Retrofit Rev. A LightSync Touch Screen Station To Rev. B TSS Wiring Details

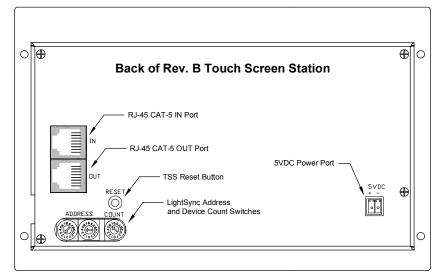
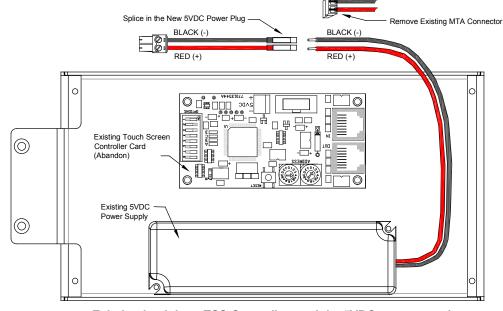
- 1. Power down the circuit to the 5VDC power supply.
- 2. Cut off the MTA connector from existing 5VDC leads.
- 3. Strip the ends of the wire and crimp on new leads, red to red, black to black.
- 4. Move LightSync CAT-5 data cables from controller card in the enclosure to the new touch screen.
- 5. Set LightSync address and switch count on touch screen to match existing settings on controller card.
- 6. Power-up and test.
